SUB-2015-78 & LUC-2015-443
380 SOUTH ROAD
RESPONSE TO REQUEST FOR FURTHER INFORMATION

Thank you for your letter of 6 November 2015 seeking further information in regard to the proposed residential development at 380 South Road, Caversham, Dunedin. Please find the applicants response below, discussed beneath the relevant subject headings.

Caversham Apartments Subdivision Scheme Plan (with Landscape Features)

Lambert
380 South Road
Sec 2 SO 23278
Caversham Apartments
Transportation Plan

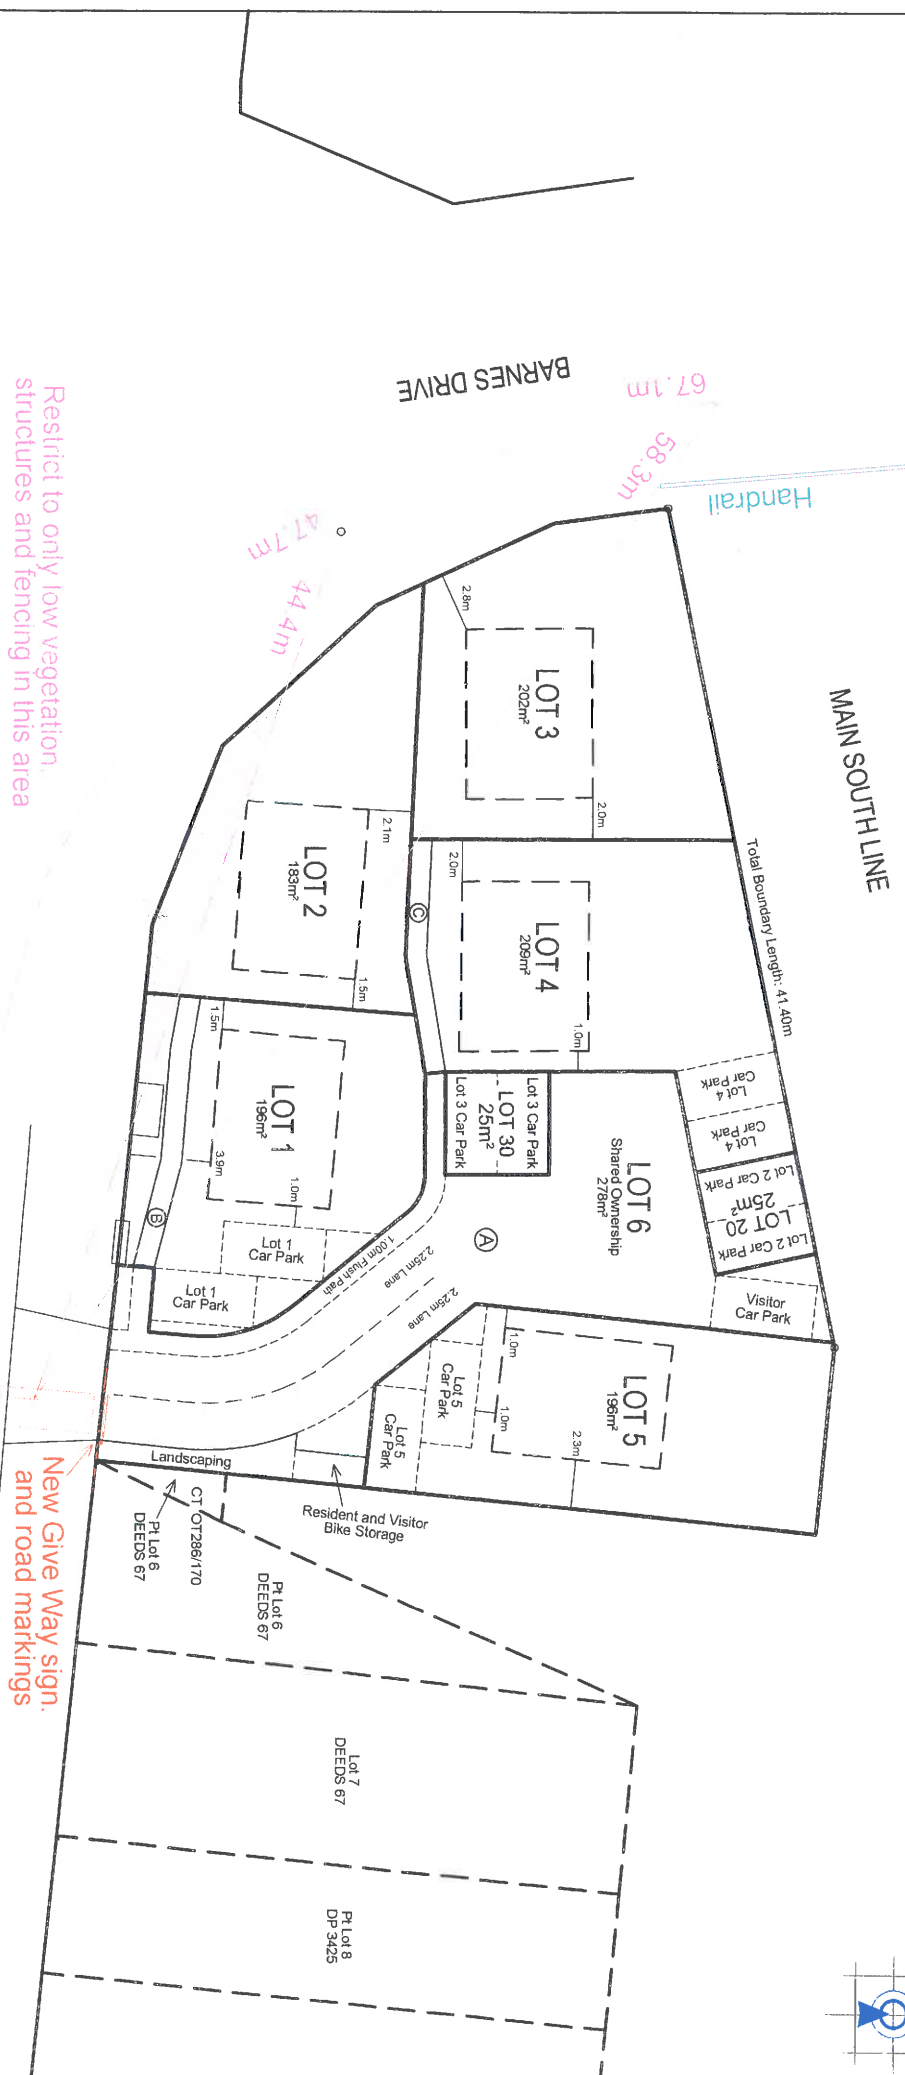
The attached plan shows various features for achieving suitable landscape management outcomes. These include requirements for certain installations and restrictions over certain activities. The plan includes provision for planted screening, larger plant specimens,

Vegetation screening is proposed along the external edges of the development site, except for the majority of the eastern boundary, the northern side of the car park area, and at the entranceway. This screening is shown in green hatching on the attached plan.

This screening will be generally 2.0m wide along the Barnes Drive and South Road boundaries (except as indicated on the plan) and will be kept reasonably low in height (maximum 0.80m). This will achieve an attractive frontage to the adjacent public roads while allowing visual sight lines across the top of the vegetation.

Taller fence screens, shown in orange double lines on the attached plan, will be established within the site at strategic location to hide utility and storage areas. These exist on south-east and south-west sides Lot 1, around the south-west side of the Lot 2 deck, on the northern side of the car parking area (with short returns at either end), and between the landscaping and bike storage facility on the eastern side of the site. These fences will again be permeable 'soft' in nature and will extend to 1.8m in height to fully screen the relevant utility and storage areas.

The landscape restriction line, shown in a dashed red line on the attached plan, will be implemented to prohibit any part of a dwelling or deck, or any closed or open-air storage facility, or any clothes line or other utility facility from being established on the south-western side of this line. The purpose of this is to ensure that the development maintains an attractive aspect when viewed from the Barnes Drive and South Road frontages.

Larger tree specimens established
interrupt the built appearance of site

Install 1.8m high permeable soft
fencing to screen utility areas

Landscaping Restriction Line
No structures permitted on the south-west of this line for the purposes of:

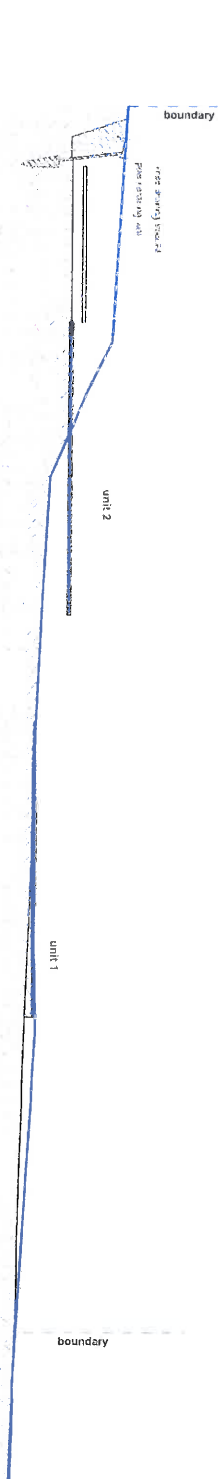
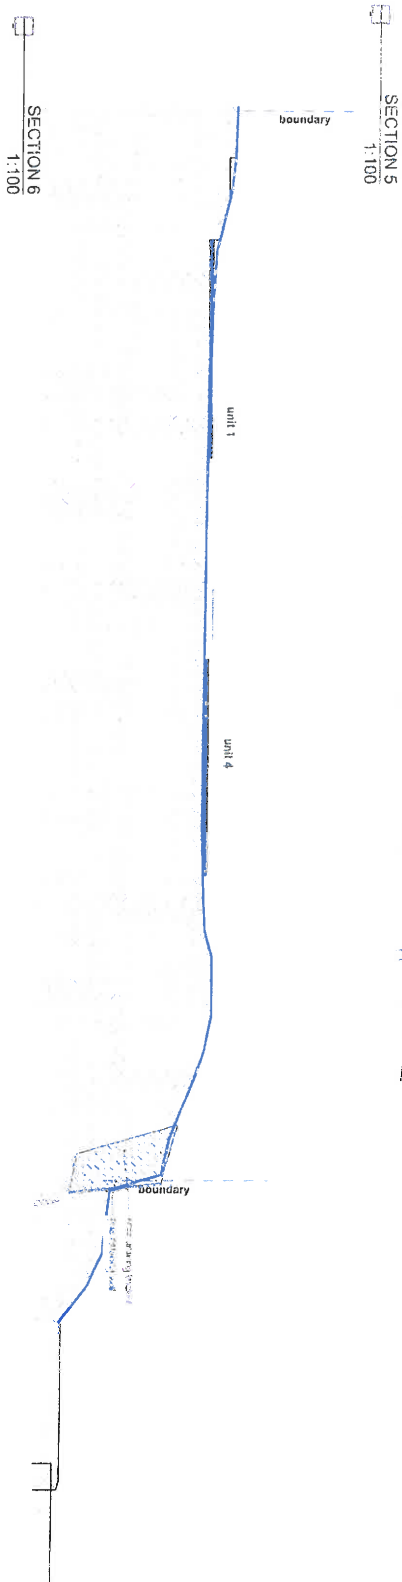
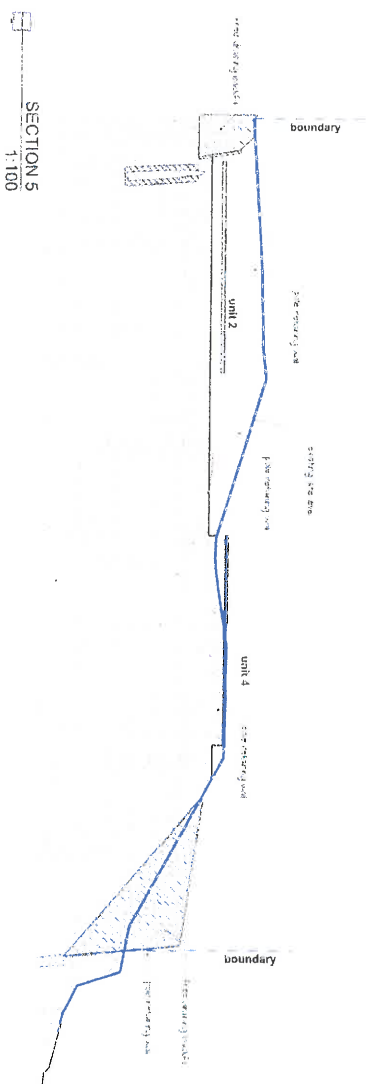
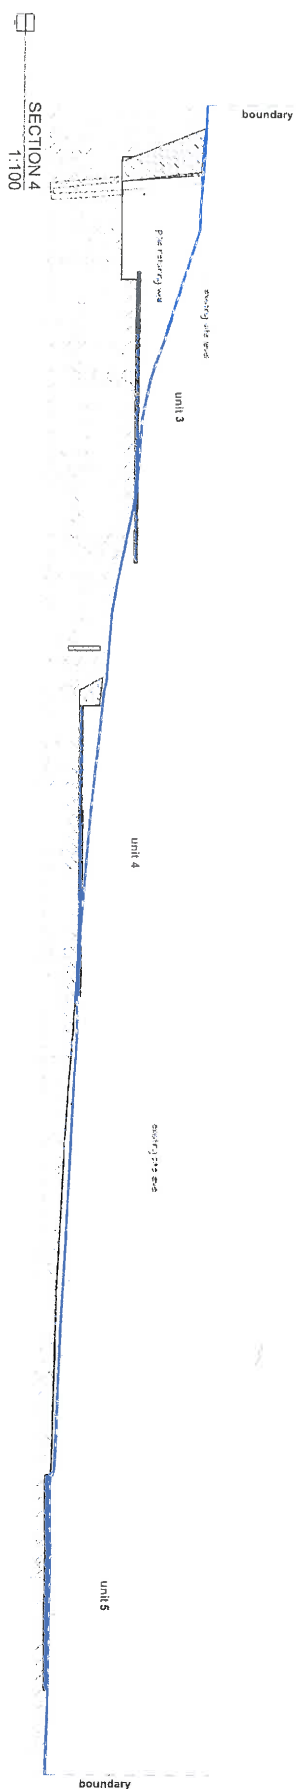
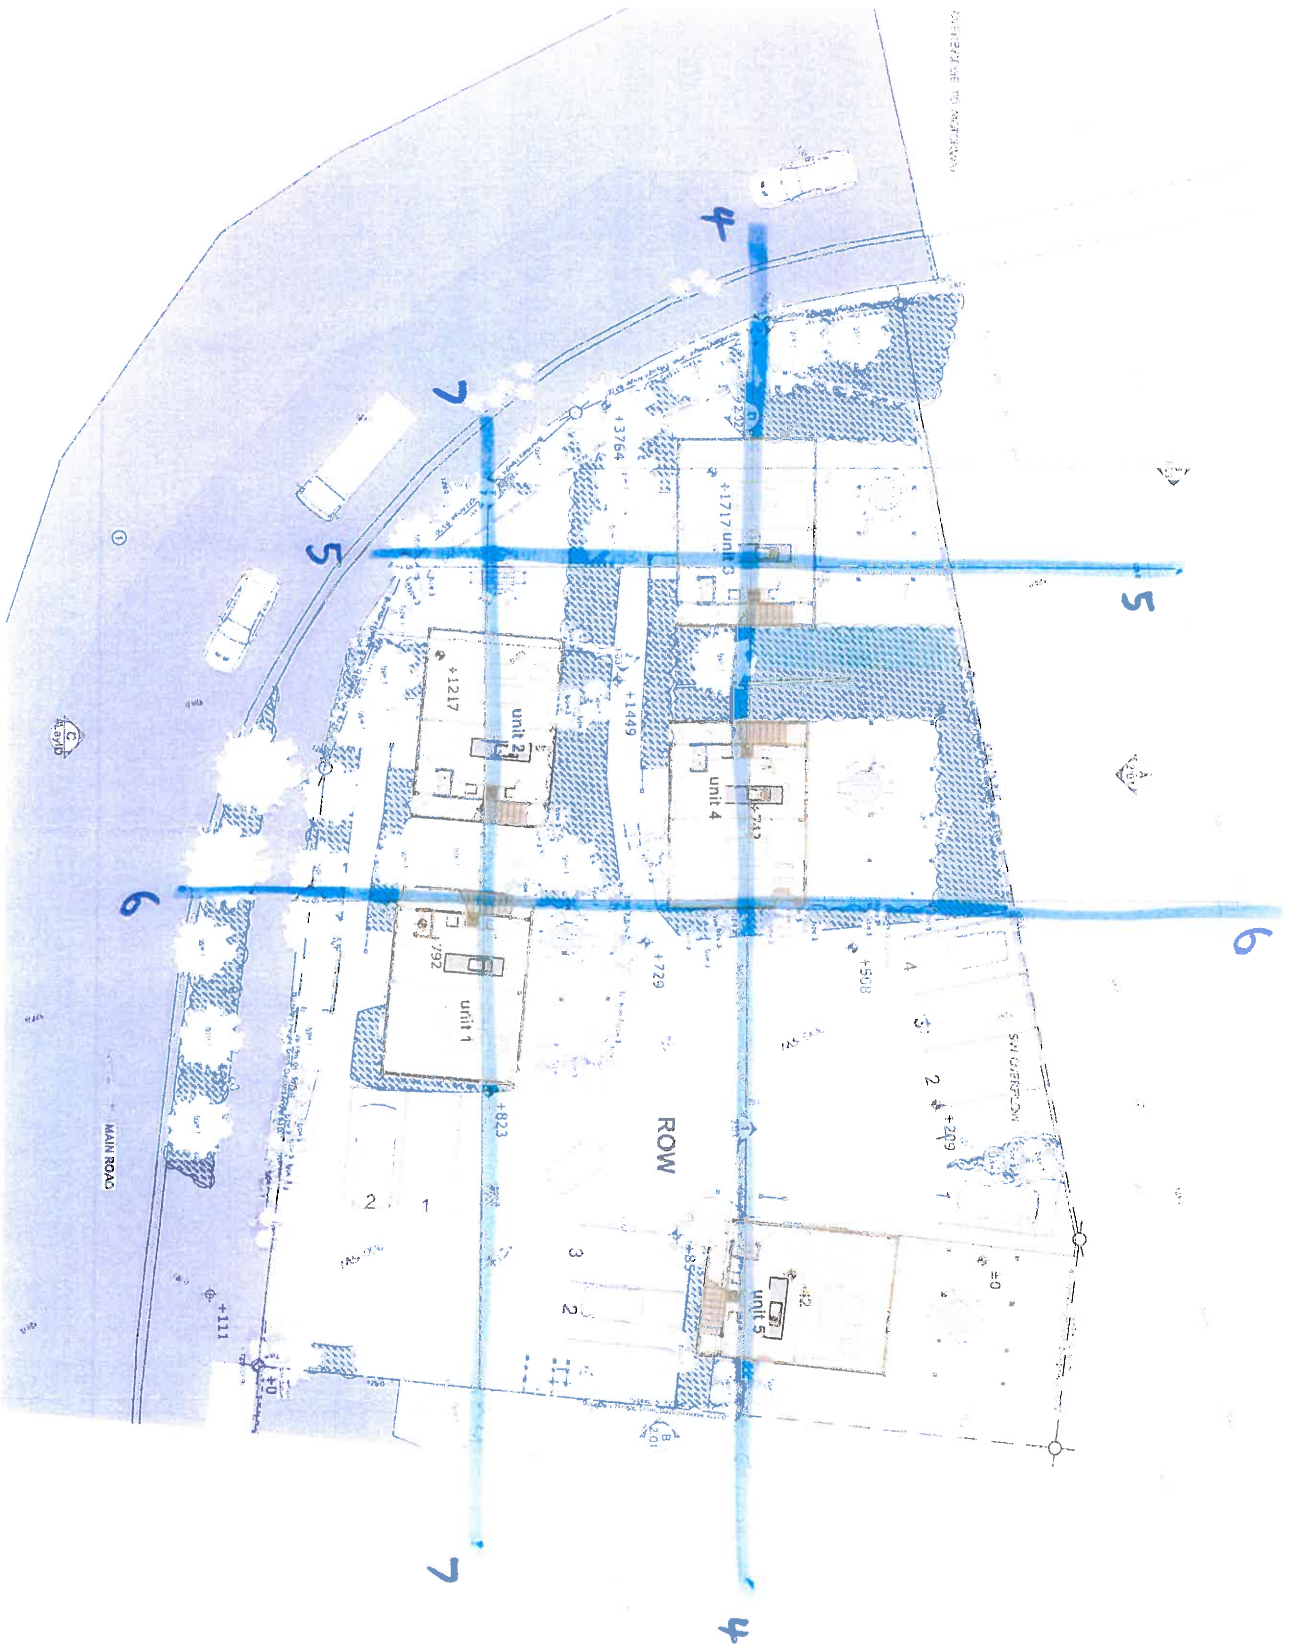
However, the applicant recognises that the establishment of the units, in the layout proposed and in particularly Unit 2, will potentially reduce the effective sight distance in a westerly direction for vehicles existing the development site. The attached plan indicates that this could be reduced from 58m to 44m. This reduction, along with the queuing lengths discussed below, appear to be the principle concerns raised by Council transportation engineer.

To address the reduced sight distance, the applicant proposes a restriction on the height of vegetation and fencing in the area indicated on the attached transportation plan as well as a new give way sign and road marking at the exit from the development site. This will ensure that a sight distance of slightly greater than 44m is maintained. The applicant considers that this distance is suitable, principally for the following reasons-

In respect to queuing, the attached plan indicates that there is sufficient space for 3 vehicles to queue in line without causing a conflict with a vehicle parked in the Lot 5 car parks, and that there is sufficient space for 4 vehicles to queue in line without causing a conflict with a vehicle parked in the Lot 1 car parks. This queuing count includes 1 vehicle parking in the road reserve awaiting entrance out onto the South Road carriageway. Given the low volume of traffic generated by the proposed development, the applicant is confident that the proposed queuing space will be sufficient.

Restrict to only low vegetation structures and fencing in this area

New Give Way sign and road markings
